Host Channel/PCB Model Parameters for P802.3dj: Addressing Comment # 537

- Comment # 537 against 802.3dj D1.1 specification was made to address the Host channel /PCB model parameter TBDs

CI 179 SC 179.11.7.1 P 360 L 8 # 537

Figure 178A-5—Host channel model

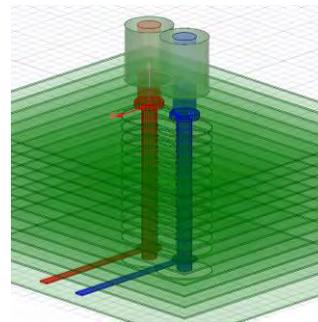
The host channel model is shown in Figure 178A-5 and is a function of the parameters summarized in Table 178A-5. It is the cascade connection of a first shunt capacitor C_0 , a transmission line, and a second shunt capacitor C_1 .

Design (I): PCB Trace

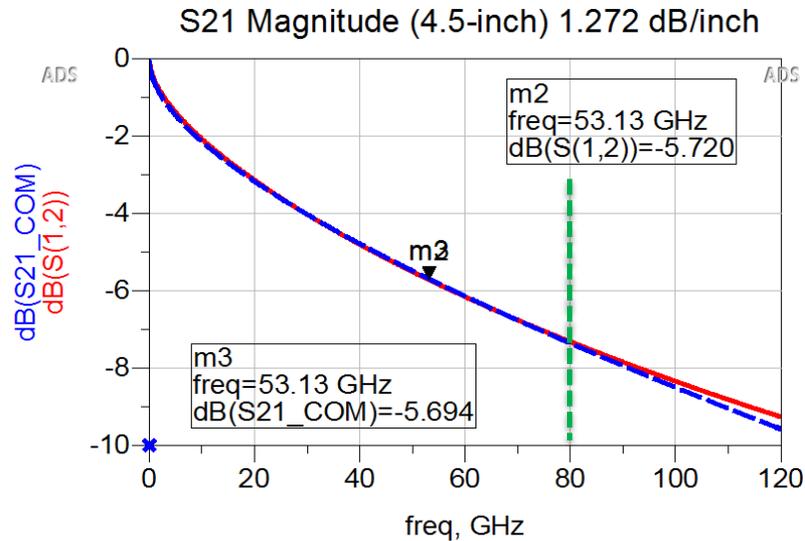
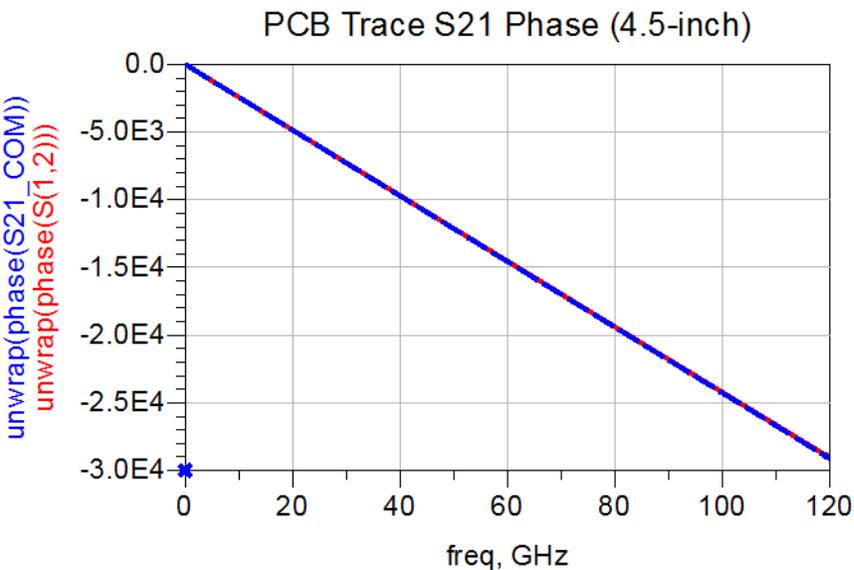
Adjust Host Channel Model Parameters to Match the 200G/L

Parameter	Value	Units
γ_0	0	1/mm
a_1	5.95e-4 >	3.8206×10^{-4} ns ^{1/2} /mm
a_2	2.6e-5 <	9.5909×10^{-5} ns/mm
τ	5.79e-3 =	5.79×10^{-3} ns/mm
C_0		2.9×10^{-5} nF
C_1		1.9×10^{-5} nF
Z_c	92.5 <	100 Ω
R_0		50 Ω

Design (II): BGA Via->PCB trace -> Connector Via

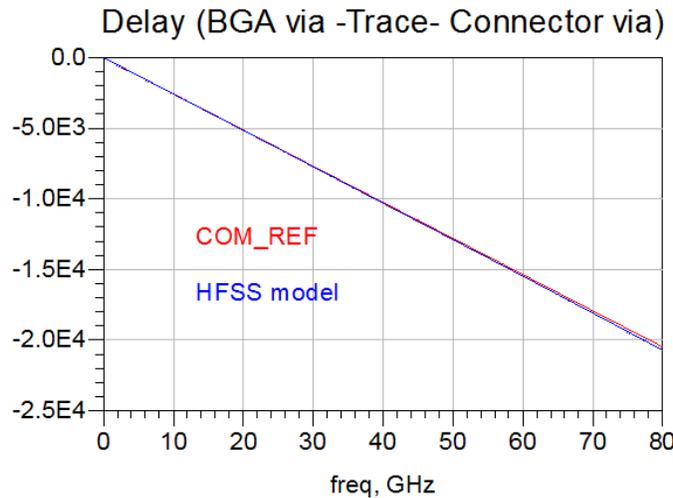
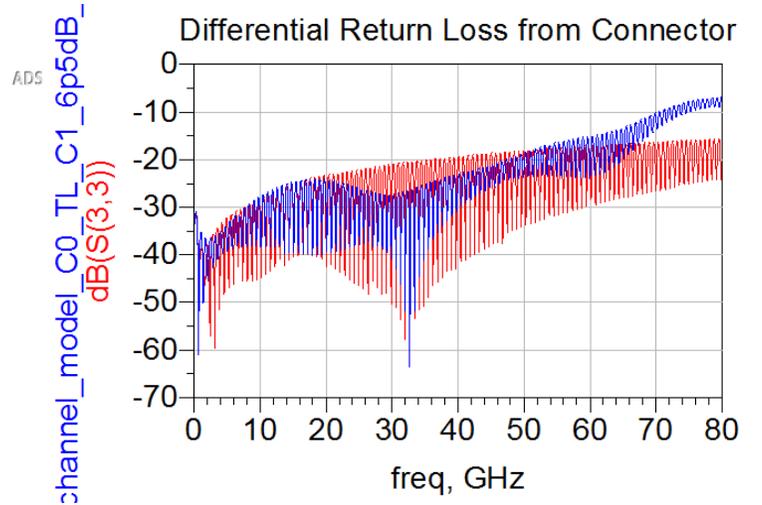
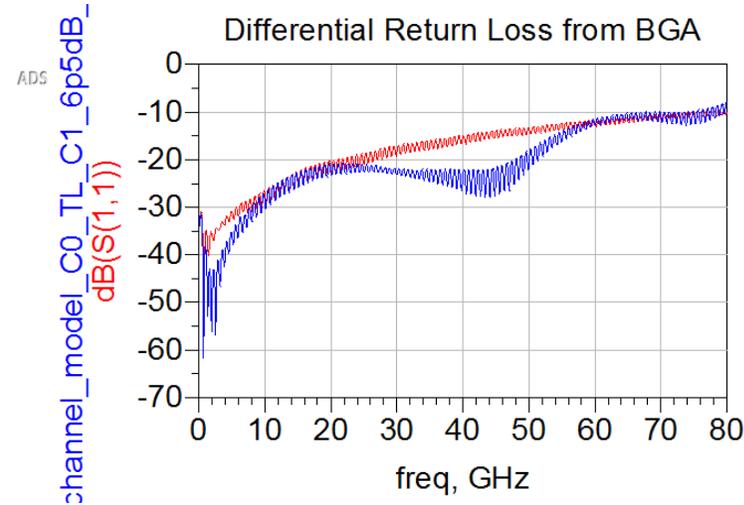
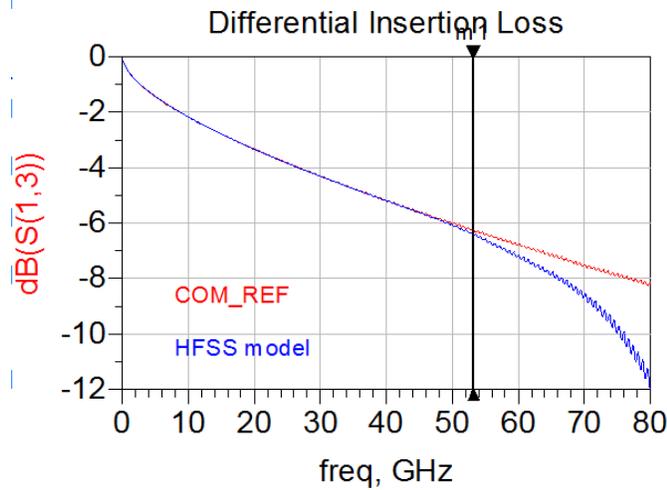
Adjust Host Channel Model Parameters to Match the 200G/L

Parameter	Value	Units
γ_0	0	1/mm
a_1 5.95e-4	> 3.8206×10^{-4}	ns ^{1/2} /mm
a_2 2.6e-5	< 9.5909×10^{-5}	ns/mm
τ 5.79e-3	= 5.79×10^{-3}	ns/mm
C_0 2.9e-5	= 2.9×10^{-5}	nF
C_1 1.0e-5	< 1.9×10^{-5}	nF
Z_c 92.5	< 100	Ω
R_0	50	Ω
